Hills of Gold Wind Farm: SSD 9679

Submission by Brenda Gerrie

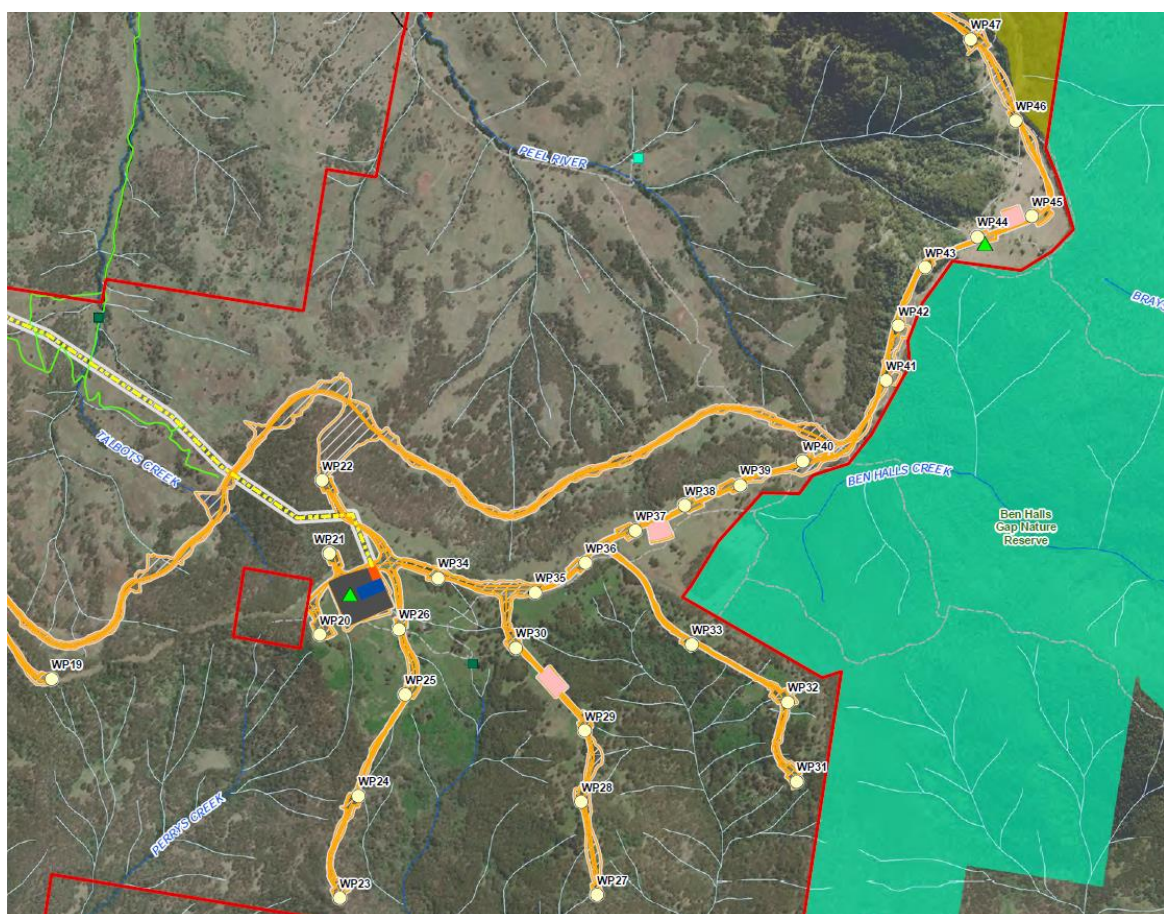
The southern edge of the wind farm has 17 turbines (WP20 to WP36) clustered in 3 overlapping fingers to create multiple layers of turbine blades spinning at different angles and speeds. Many of these turbines have a separation distance of less than 3R (refer to Table 1 in Appendix 1). This cluttering effect will increase the visual impacts even more and increase noise levels.

But the southern end of the Reserve is also where the cluttering effect is at its worst with 17 turbines in 3 overlapping fingers. This creates a wall of overlapping turbines – as many turbines as will fit on that narrow section of ridgeline – forming a dangerous and possibly impenetrable barrier for the raptors who live in the Nature Reserve and hunt in the valleys and farmland below. The following image taken from page 73 of the EIS shows the cluttering effect and the turbines adjoining the Reserve.

Bar Chart 1

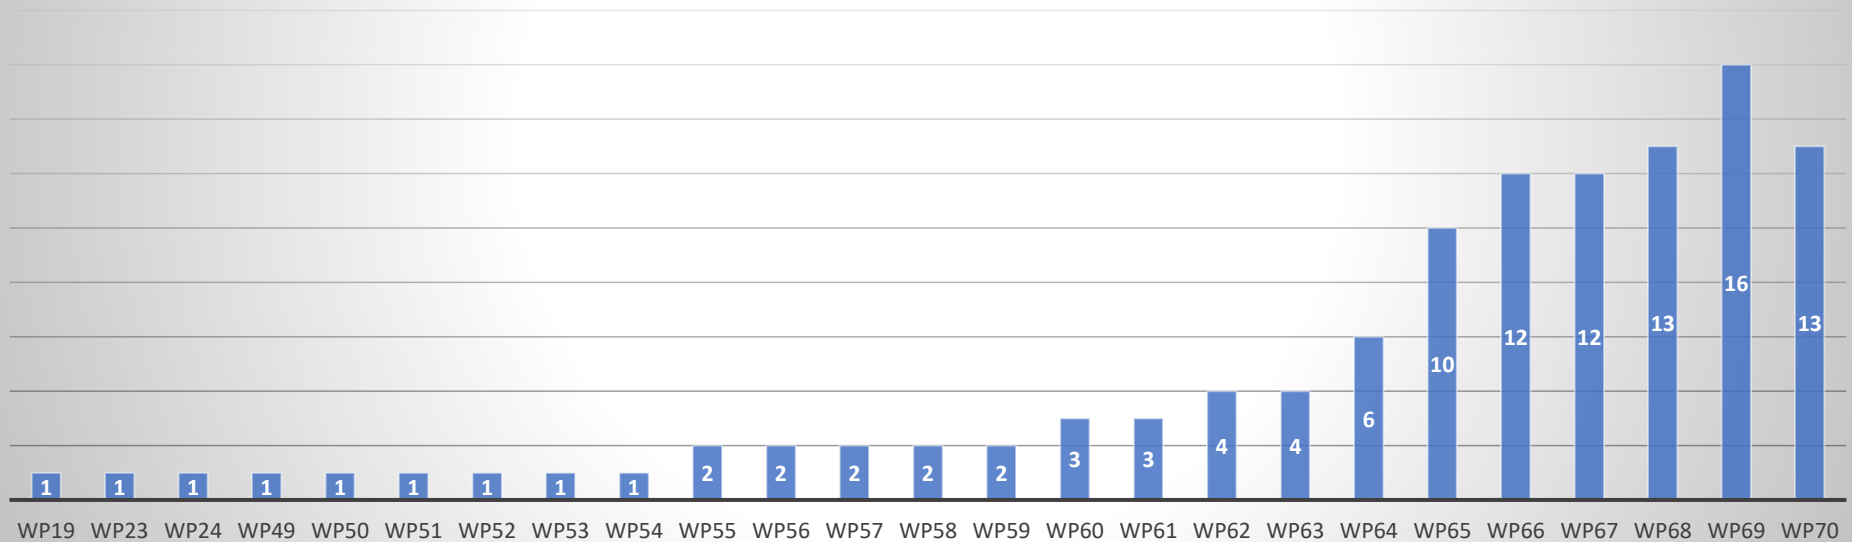
Bar Chart 1 identifies 22 non-associated dwellings (almost one third of the community in the vicinity) which are likely to experience HIGH visual impact because they live within 3100m of turbines. The 3 worst affected dwellings are NAD_67, NAD_5 and NAD_10a which have 17, 11 and 10 turbines respectively within 3100m. NAD_67 on Morrisons Gap Road has an eye level panoramic view of turbines across 4 60° sectors, the closest turbine being 1422m away. NAD_5 is down in the valley at the end of Nundle Creek Road some 400-500m below the ridgeline with 180° views of 30 or more turbines, the closest being 1795m away. The EIS asserts that vegetation screening would reduce views of towering turbines. This is highly unlikely. NAD_10a is also on Nundle Creek Road where vegetation screening might reduce their views of the valley, but not of turbines 500m above them.

Bar Chart 2

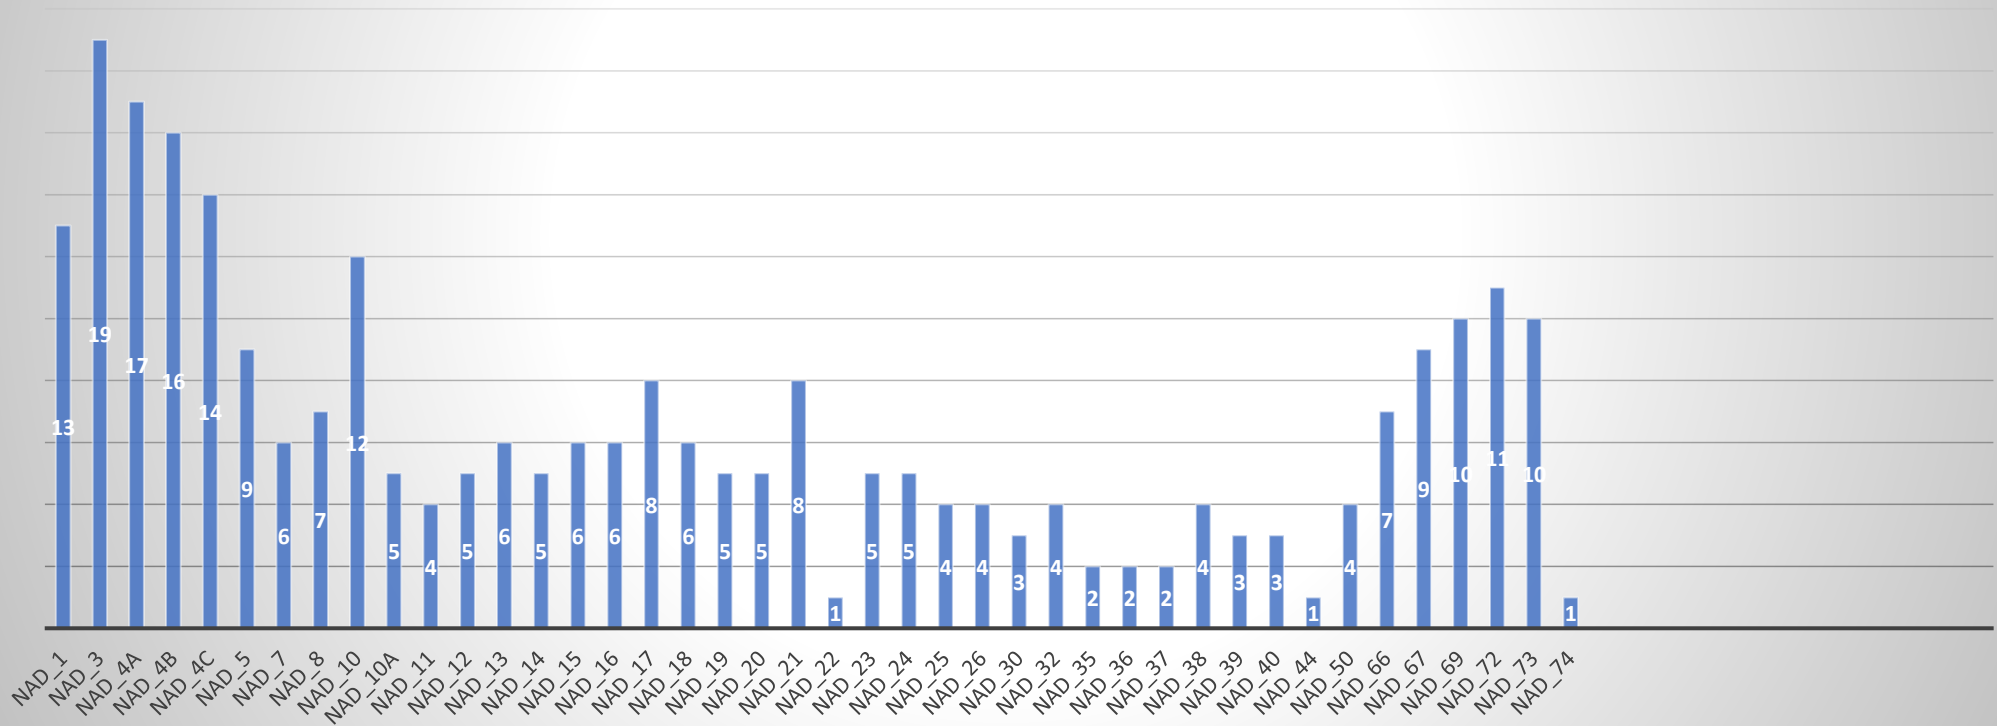
Bar Chart 2 identifies the 25 HIGH impact turbines which are closer than 3100m to non-associated dwellings. They are WP19, WP23, WP24 at the southern extremity of the wind farm and turbines WP49 to WP70 in the northern section.

Bar Chart 3

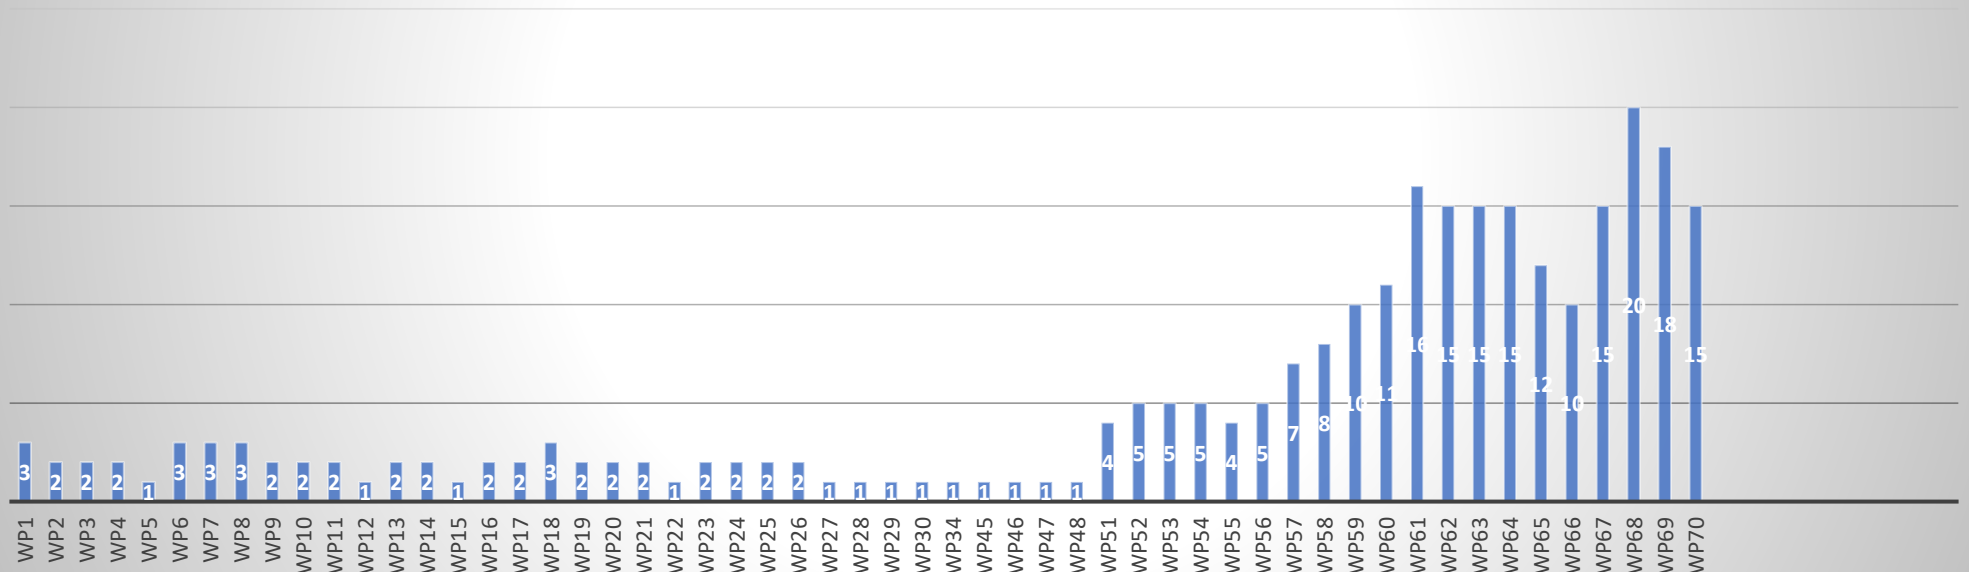
Bar charts 3 and 4 identify the 42 dwellings and 55 turbines within the MEDIUM visual impact zone from 3100m to 4550m. And again, there is nothing in the EIS to justify placing most of the turbines so close to over one half of the non-associated dwellings.

Bar Chart 5

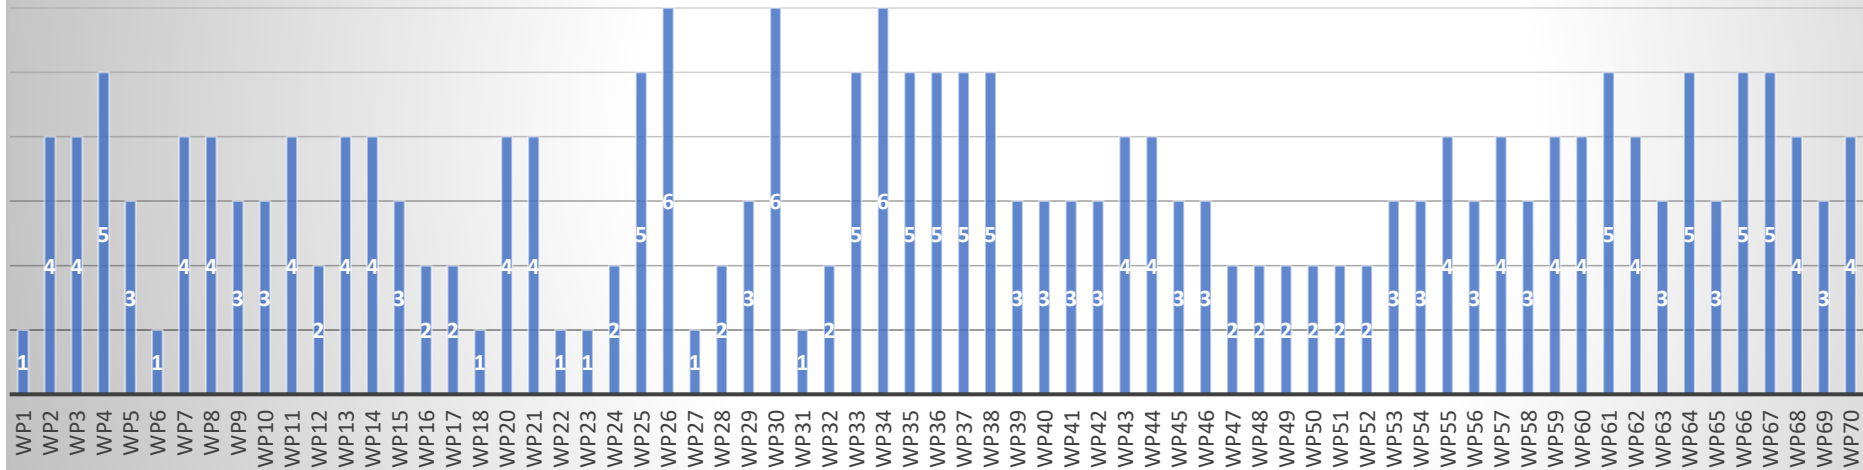
Bar Chart 5 identifies 54 turbines with a separation distance of less than 3 rotor diameters (calculated using turbine GPS coordinates) and counts the number of instances where that separation distance occurs for each turbine. Roughly 50% Of these turbines have more than one other closer than 3R in little clusters throughout the wind farm.
